RE: Nos. 110-114 Herring Road, Macquarie Park - Section 75W Modification of MP10_0112 Concept Plan Approval and MP 10_0113 Stage 1 Project Approval (MOD 5)

This letter has been prepared to respond to Council's email to the Department of Planning on 26 February 2015. Council's email indicates their support of MOD 5, which amends the plans to comply with the PAC determination of 21 November 2015 (MOD 3).

**Re: Section 75W Application relating to 110-114 Herring Road, Macquarie Park
Concept Plan Modification (MP10_0112 MOD 5) and Stage 1 Project Approval
Modification (MP10_0113 MOD 5)
Traffic Statement – Design of Traffic Elements**

Service Vehicle Swept Paths

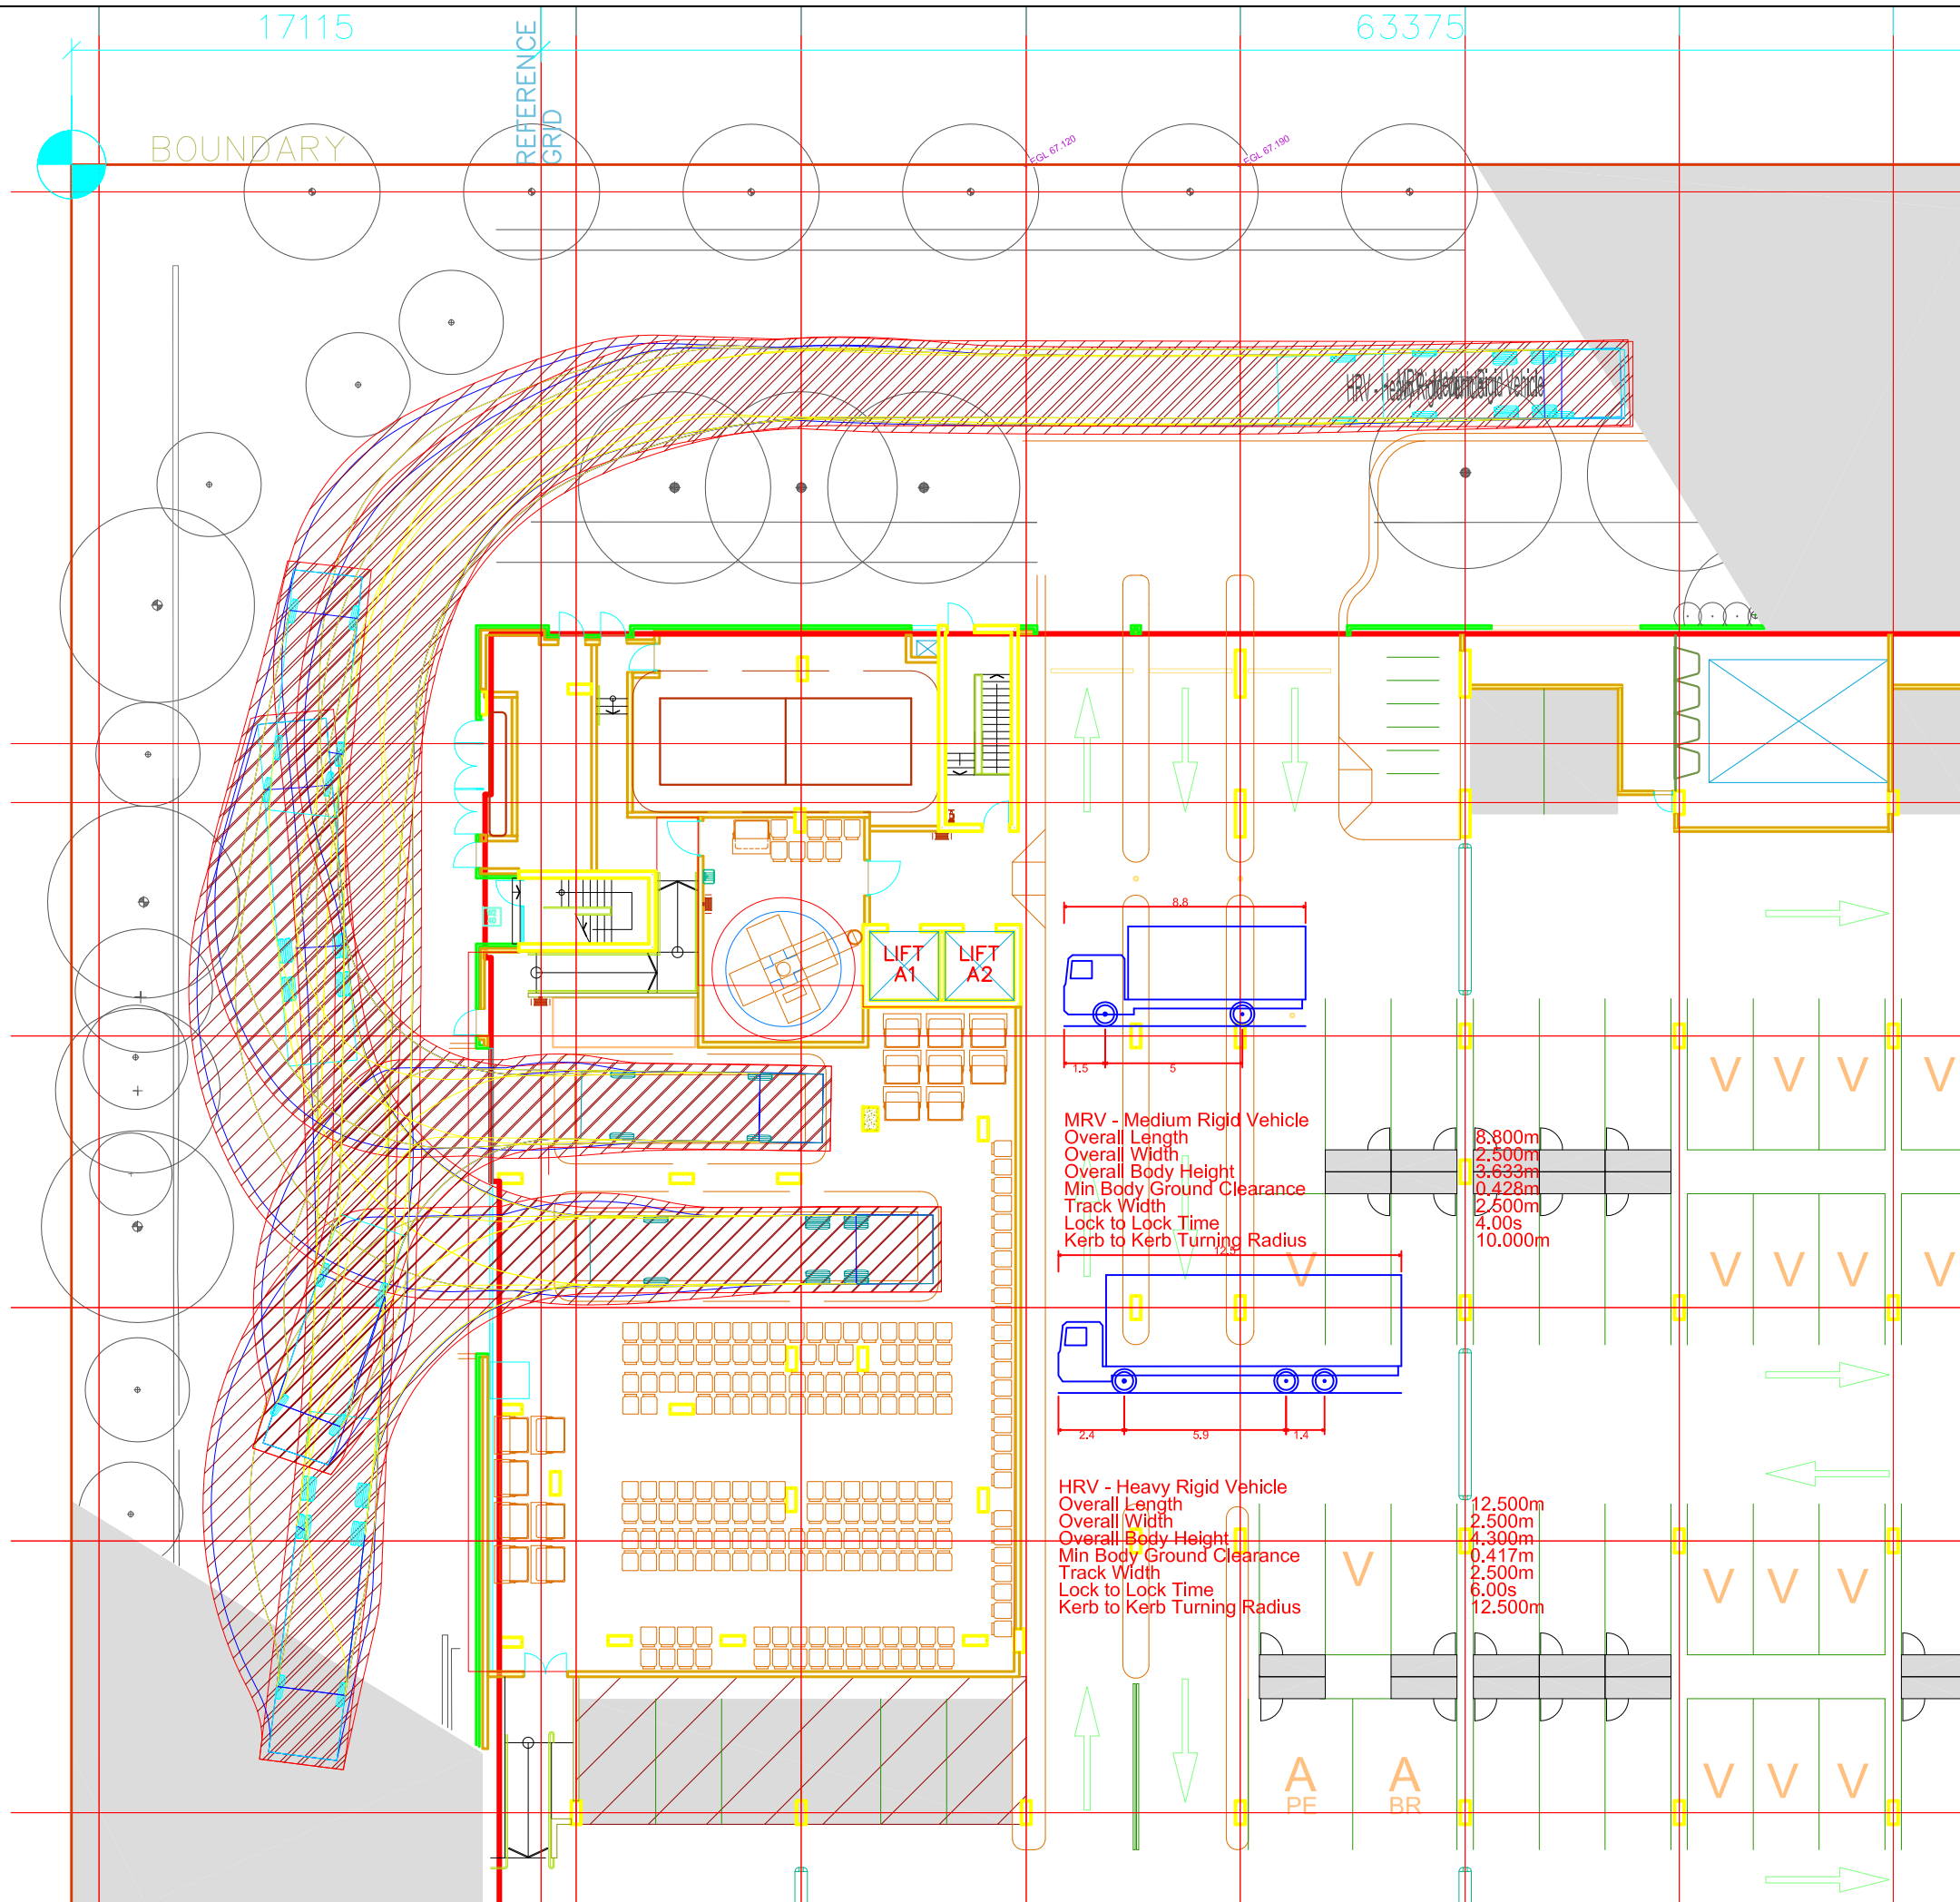
Council has requested more information to confirm that the car parking complies with relevant standards, including layout, driveway grades, clearances, and is functional in terms of security separation of areas, service vehicles.

Service vehicles will enter and exit the site via Herring Road. A centralised servicing / refuse collection area catering for a 12.5m Heavy Rigid Vehicle and an 8.8m Medium Rigid Vehicle is proposed at the north-western corner of the site. This loading area will be accessed via the internal circulation roadway, which has been designed to accommodate up to a 12.5m Heavy Rigid Vehicle. A clear height of 4.5m will be provided within the loading area to cater for these vehicles.

Swept path diagrams showing service vehicle access, manoeuvring, and egress have been provided with previous applications, but have been updated based upon revised drawings and are included as **Attachment B**. As shown in this drawing, a 12.5m Heavy Rigid Vehicle and an 8.8m Medium Rigid Vehicle would be able to undertake the necessary manoeuvres to access and egress the two loading bays proposed. The reverse manoeuvres would be contained within an area which will not be used by passenger vehicles, and which is isolated from key pedestrian routes and desire lines.
